MIAMI BEACH

Staff Report & Recommendation

Historic Preservation Board

SUBJECT: HPB17-0099, **947 Lincoln Road.**

Image 1: Michigan Avenue façade as proposed by the applicant

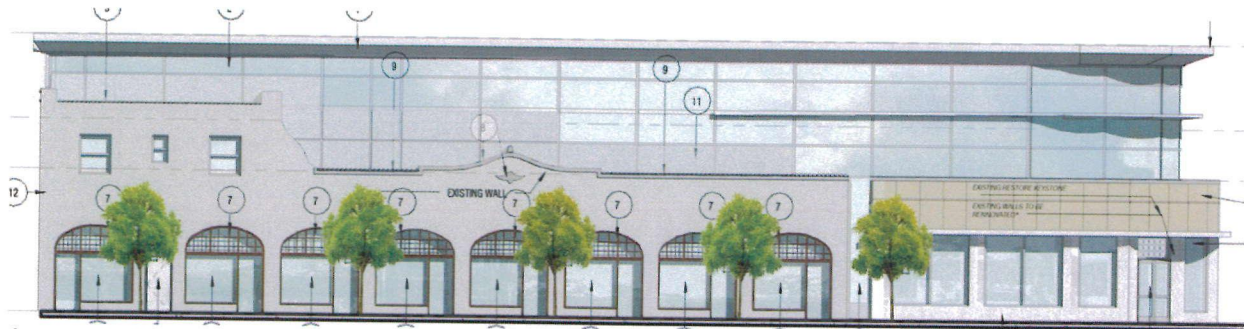
- a. Exterior architectural features.
Not Satisfied
The portion of the Michigan Avenue façade to be reconstructed is inconsistent with the historical design evolution of the building.

- The applicant is proposing to retain and restore the primary facades with the exception of an approximately 30'-0" section of the Michigan Avenue. This portion of the building was not part of the 1938 Dixon renovation, has been significantly altered and contains little to no significant architectural features.
- The applicant is proposing to retain and restore the north (alley) façade.
- The design of the new addition has been refined including the elimination of the metal cladding. Further horizontally proportioned windows and a projecting eyebrow and overhang have been introduced which floor help to break down the scale of the addition.

Staff believes that the proposed modifications outlined above and either of the recommended Michigan Avenue options address the concerns of the Board and staff and should significantly reduce potential adverse impacts on the character of the Contributing structure and the surrounding historic district. Staff does however, have one concern with regard to the design of the portion of the Michigan Avenue façade that is proposed to be demolished and reconstructed. This portion of the building is proposed to be rebuilt in a manner consistent with the 1938 Dixon design, extending the keystone cladding northward (Image 1 on following page). It should be noted however, that this portion of the façade was not part of 1938 Dixon design. As such, staff would recommend that this portion of the façade not be reconstructed and that the new glass storefront system of the proposed addition be brought down to the ground level (Image 2 on following page). Alternatively, staff would recommend that the portion of the wall to

- a. The portion of the Michigan Avenue façade to be demolished shall not be reconstructed to match the 1938 design. Instead, the glass storefront system of the proposed addition shall be extended down to the ground level within this area, in a manner to be reviewed and approved by staff consistent with the Certificate of Appropriateness Criteria and/or the directions from the Board. Alternatively, this portion of the facade shall be reconstructed in accordance with the 1924 design including the arched openings.

Image 3: Alternate concept of Michigan Avenue façade as recommend by staff

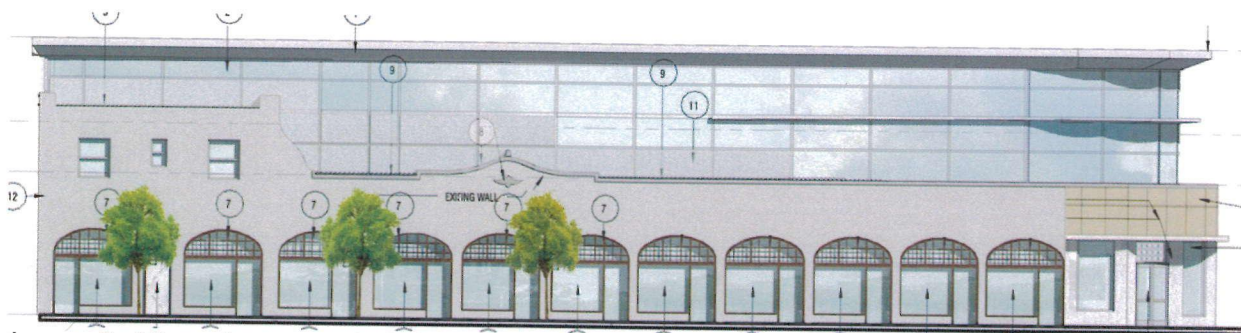
be demolished be reconstructed in accordance with the original 1924 design including the arched openings. (Image 3 below).
